**DELDOT Administration Building**  
**Roof Replacement and Repairs**  
**800 Bay Road**  
**Dover, Delaware**

**ADDENDUM No. 4**  
**February 11, 2014**

**OMB/DFM Contract No. MC5511000007**

### ADDENDUM 1.0 PRE-BID MEETING

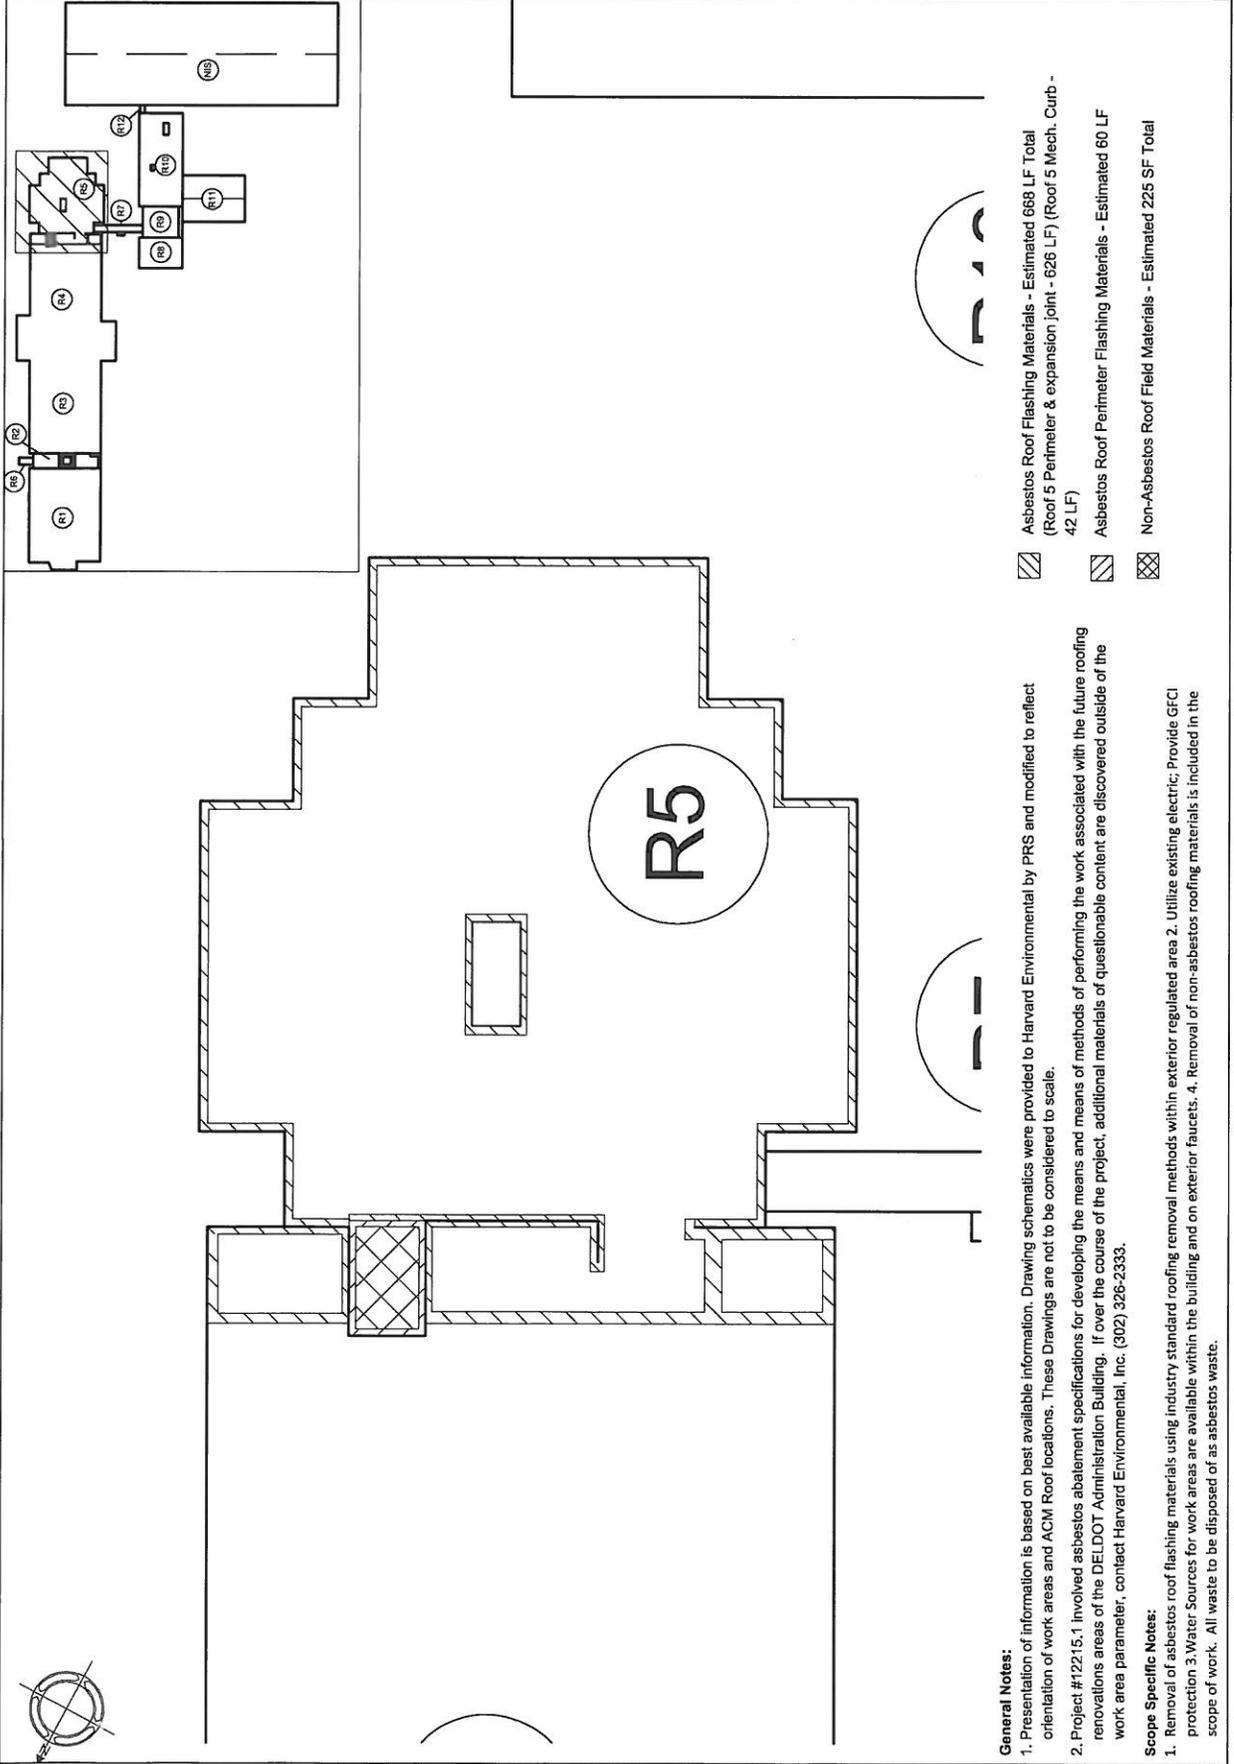
- 1.8 ***A revised drawing is attached to this addendum and identifies additional flashing materials near the expansion joint.***
- 1.9 Contractor shall provide fall protection (harnesses and lanyards) for the asbestos personnel.
